January 2011 Flood Event: Report on the operation of Somerset Dam and Wivenhoe Dam

REVIEW OF HYDROLOGICAL ISSUES

- Final A
- 11March 2011

Figure 4.1 Comparison of eight day rainfall totals recorded by Seqwater and Bureau of Meteorology gauges to 13 January 2011.

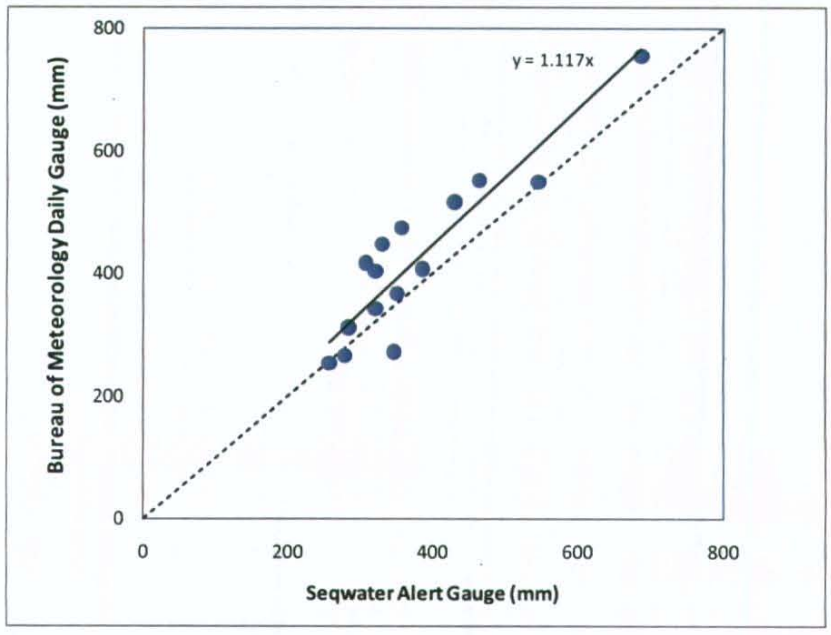
Figure 4.1 below shows that there is generally good agreement in the rainfall totals at the pairs of stations. There appears to be a small bias with the daily read values approximately 10% higher than the ALERT values. The reason for this relatively small bias was not explored but could possibly be attributed to the tendency for the ALERT gauges in the lower rainfall portions of the catchment. However, give the close proximity of the station pairs the difference it is speculated that the most likely reason for the bias might be due to differences in standard installation details (such as distance from the ground and exposure of the site).

The generally good agreement between the ALERT and daily read data confirms that the ALERT data is appropriate to support flood operations decision making in real time. In real time the tendency of the ALERT data to slightly underestimate the rainfall totals when compared to the daily gauges is compensated by the progressive calibration of the loss model during the event, and by closing the water balance at the reservoir itself.

Figure 4.2 Progressive comparison of 24 hour catchment average Quantitative Precipitation Forecasts versus actual values.

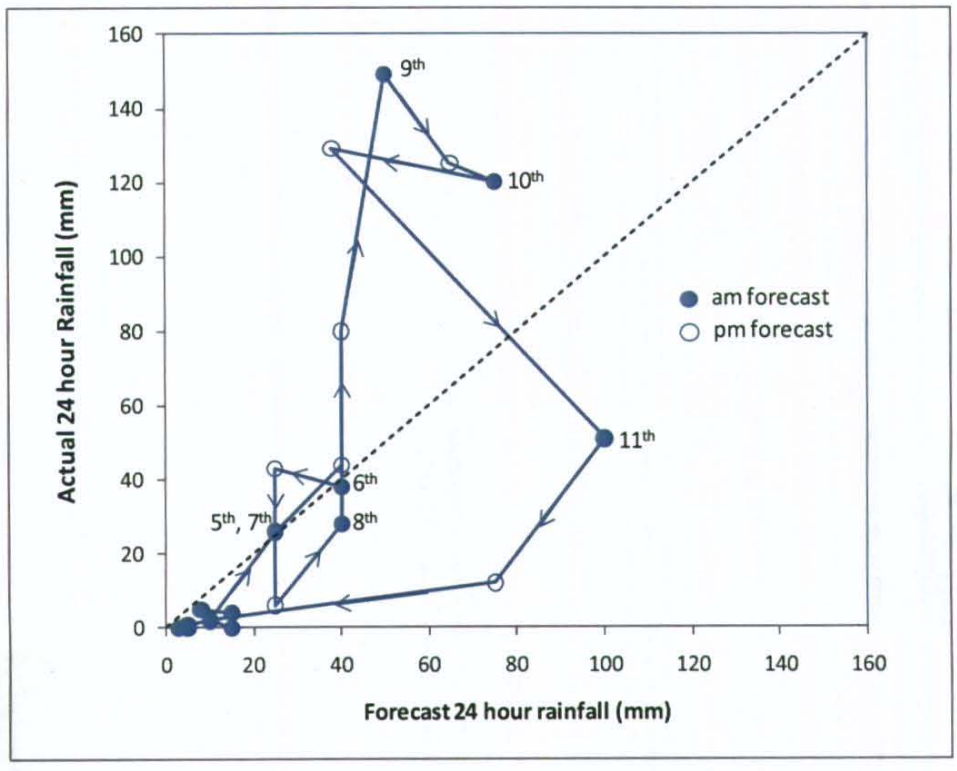
The performance of the 24 hour catchment average Quantitative Precipitation Forecasts provided by the Bureau of Meteorology is illustrated graphically in Figure 4.2. It is seen that the forecasts leading into the first and second major flood peaks (morning of the 9th and afternoon of the 10th) were around one third the actual. The forecast following the second peak (on the 11th) were around twice the actual.

Figure 4.3 Progressive comparison of forecast versus actual 24 hour spatial rainfall distribution.

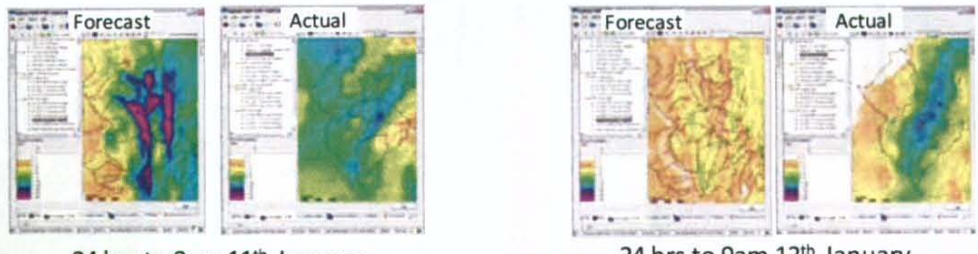
In terms of spatial accuracy, it is seen in Figure 4.3 (from Seqwater Appendix J) that the 24 hour forecast made at 9am on the 10th does indicate very heavy rainfall over the Stanley catchment and in the immediate vicinity of Wivenhoe Dam. However the 24 hour forecasts for 9am on the 11th does not pick up the heavy rain in the immediate vicinity of Wivenhoe (which supports the inference discussed in the previous section regarding the sharp rise in reservoir level).

Figure 4.3 Progressive comparison of forecast versus actual 3-day and 5-day rainfall totals.

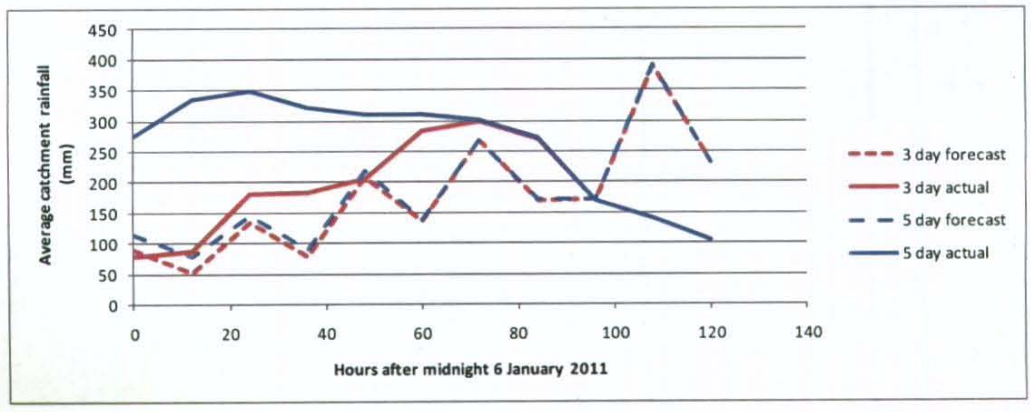
Figure 4.3 also highlights two features of particular interest:

- The difference between the 3-day and 5-day ACCESS forecasts is negligible throughout the event, which indicates that the rainfall was always expected to fall predominately within a 72-hour period; and,
- The successive forecasts fluctuate around a mean trend prediction by an alternating divergence of around 30% – there is little apparent persistence between successive forecasts which is not consistent with physical reasoning.

Figure 4.4 Forecast streamflows undertaken at 7pm on the 9th and 4am on the 11th January.

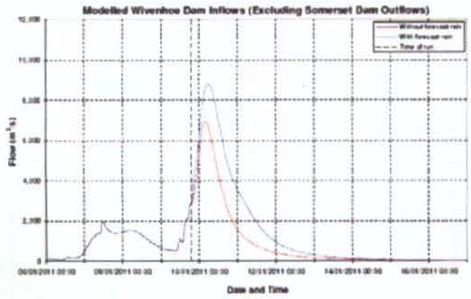
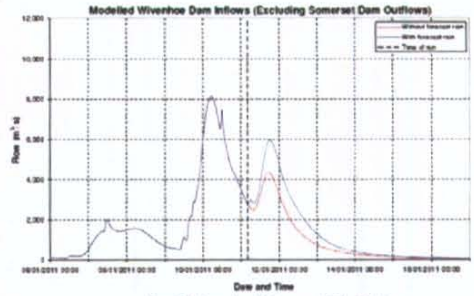
With respect to Run 21, the model predicted an inflow peak of around 8,800 m^3/s, which is only about 5% lower than the computed peak (Table in Section 9 of the Seqwater report); the timing of the peak was correctly forecast to be some 12 hours later. It is assumed that the forecast was made using the 24 hour rainfall forecast that was around 50% lower than what actually occurred.

With respect to Run 35, the model predicted the second inflow peak of around 6,000 m^3/s, which is around 55% lower than the computed peak; the timing of the peak was forecast to be some 14 hours later, which is a little later than what actually occurred. It is worth noting that the streamflow forecast was made when the previous 24 hour rainfall forecast was around 30% less than what actually occurred.

It is hard to see how these forecasts could be improved upon. In both cases the streamflow gauges further upstream in the catchment had only just commenced to rise again after the previous flood recession. The model is integrating the upstream flows that were recorded and routing them downstream to the reservoir, and there is insufficient forecast rainfall to magnify the flood response.

Figure 5.1 Spatial analysis of exceedance probabilities of 48 hour rainfalls.

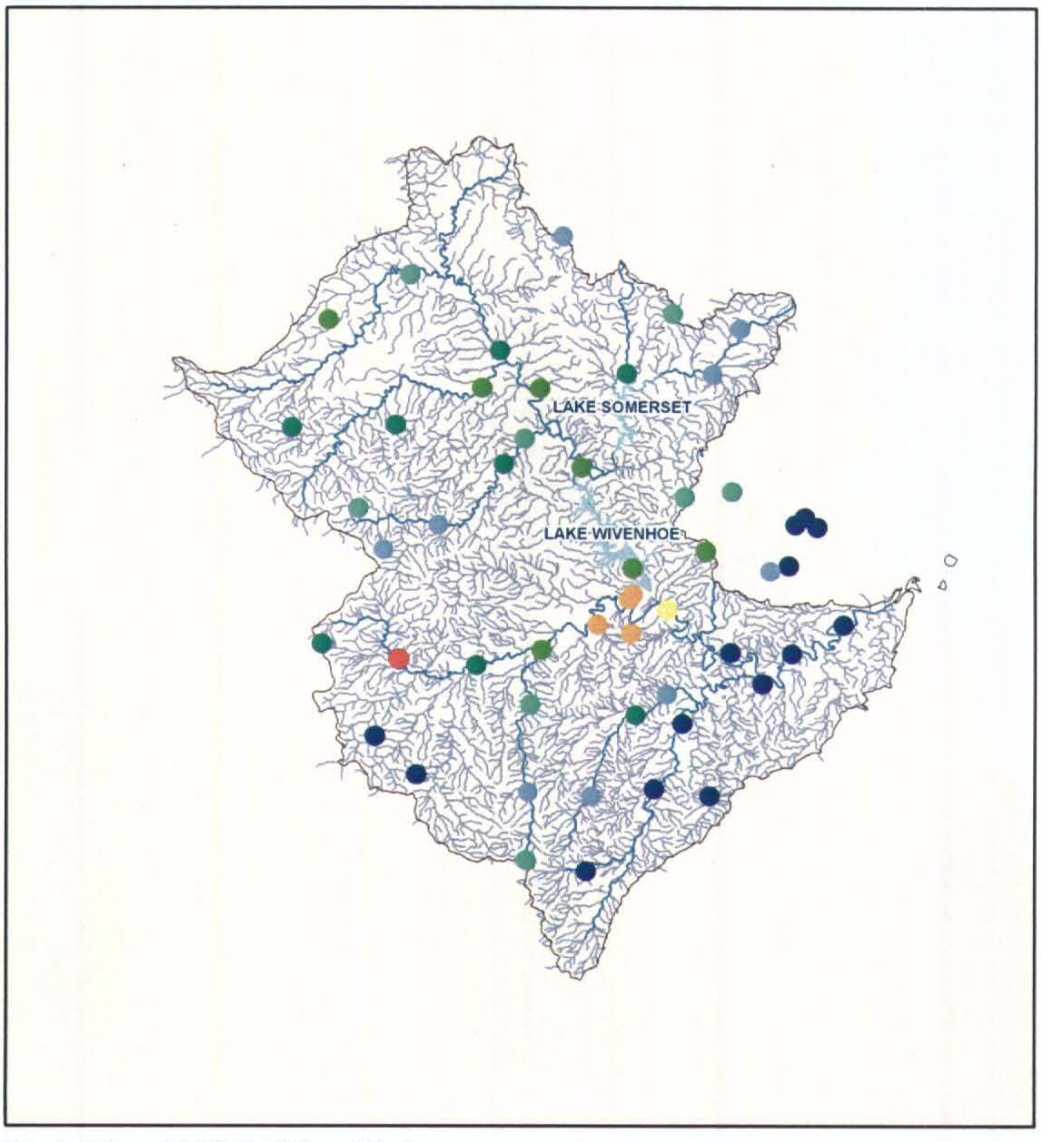
On the basis of Figure 5.1 it may be inferred that:

- The most extreme point rainfalls occurred in the centre of the Brisbane River catchment, in the areas immediately below Wivenhoe Dam – the annual exceedance probability of these rainfalls are between 1 in 500 and 1 in 2000;
- The annual exceedance probability of point rainfalls varies between around 1 in 20 at the upper reaches of the catchment above Wivenhoe Dam, to beyond 1 in 100^{+} in the lower reaches; and,
- The most intense region of localised rainfall occurred in the headwaters of the Lockyer Valley.

The above information is consistent with the exceedance probabilities of the catchment average rainfalls presented in Figure 8.4.2 of the Seqwater report (as derived using CRC-FORGE information). On this basis, it seems reasonable to assume that the annual exceedance probability of the catchment average rainfalls upstream of Wivenhoe Dam is between 1 in 100 and 1 in 200.
